CHANGE/ERRATA INFORMATION

ISSUE NO: 1 11/94

Title: 2280 Series Service
Part Number: 753111
Print Date: February 1985
Rev. & Date: 2, 1/90

Figure A.

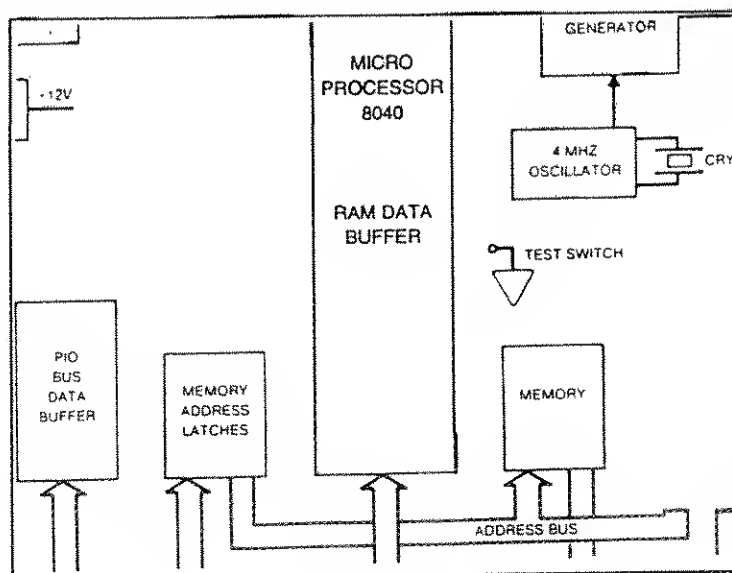
On page 341-2, Figure 341-1, delete the RAM DATA BUFFER, add it inside the MICRO PROCESSOR and change MICRO PROCESSOR 8039 to 8040 as shown in Figure A.

Figure B.

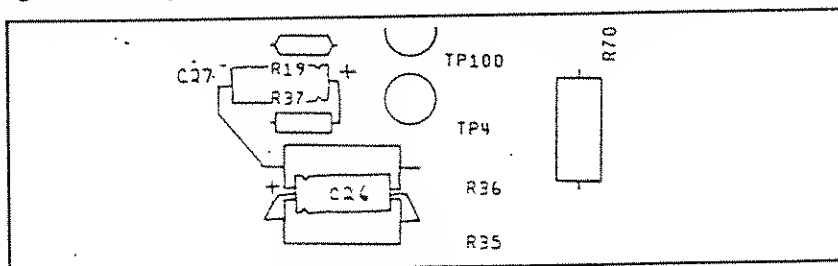
On page 164-15, Figure 164-5, add C26 and C27 as shown in Figure B.

ADD: C26, 27/CAP,AL,47UF,+75-20%, 25V/655191/89536/655191/2

Figure C.

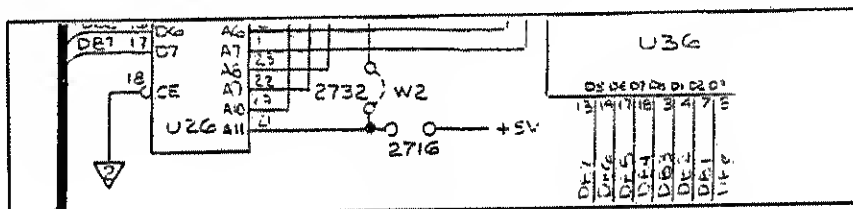
On page 161-F2, Figure 161-7, change the location of jumper W2 to 2732 as shown in Figure C.
